ORDINANCE NO. 2164

AN ORDINANCE AMENDING THE HURST CODE OF ORDINANCES BY AMENDING CHAPTER 5 OF THE HURST CODE OF ORDINANCES, BUILDING REGULATIONS. ADOPTING THE 2009 EDITIONS OF THE INTERNATIONAL RESIDENTIAL CODE, INTERNATIONAL ENERGY CONSERVATION CODE, INTERNATIONAL BUILDING CODE, INTERNATIONAL PLUMBING CODE, INTERNATIONAL FUEL GAS CODE, INTERNATIONAL MECHANICAL CODE, INTERNATIONAL PROPERTY MAINTENANCE CODE AND THE 2011 EDITION OF THE NATIONAL ELECTRICAL CODE INCLUDING AMENDMENTS AND DELETIONS TO EACH CODE; AUTHORIZING THIS ORDINANCE; PROVIDING A SAVINGS CLAUSE; PROVIDING A PENALTY CLAUSE; AND PROVIDING AN EFFECTIVE DATE.

FIGURE R602.6.1
TOP PLATE FRAMING TO ACCOMMODATE PIPING

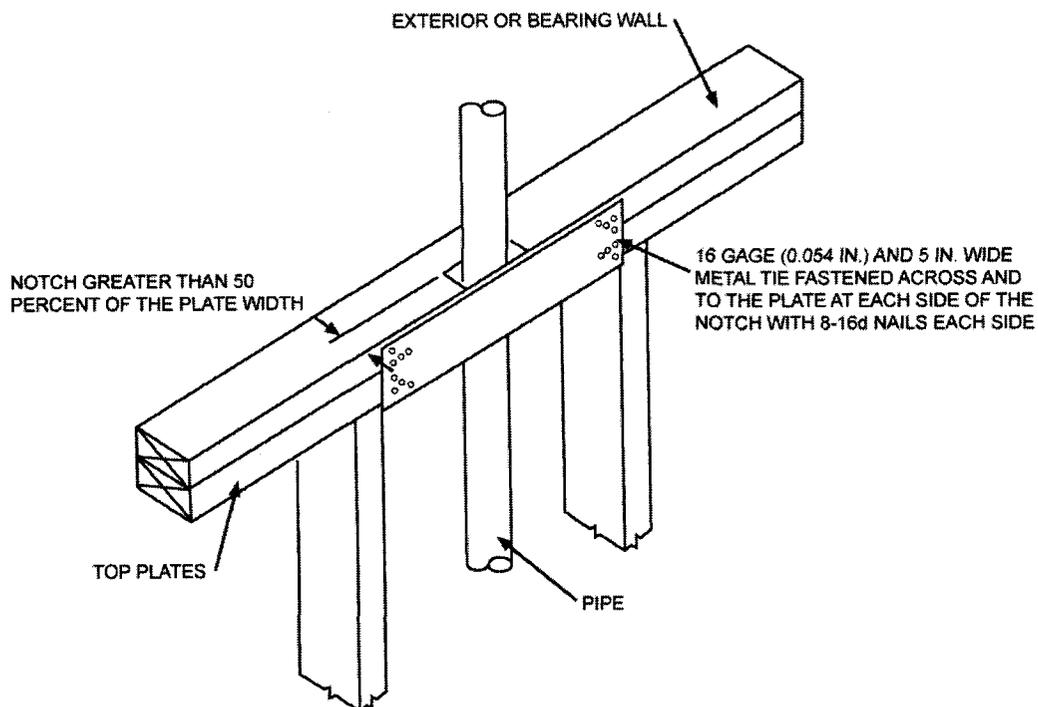
*****Figure R602.6.1; delete the figure and insert the following figure:**

R602.6.1 Drilling and notching of top plate. When piping or ductwork is placed in or partly in an exterior wall or interior load-bearing wall, necessitating cutting, drilling or notching of the top plate by more than 50 percent of its width, a galvanized metal tie not less than 0.054 inch thick (1.37 mm) (16 Ga) and 5 inches (127 mm) wide shall be fastened across and to the plate at each side of the opening with not less than eight 10d (0.148 inch diameter) having a minimum length of 1 ½ inches (38 mm) at each side or equivalent. Fasteners will be offset to prevent splitting of the top plate material. The metal tie must extend a minimum of 6 inches past the opening. See figure R602.6.1.
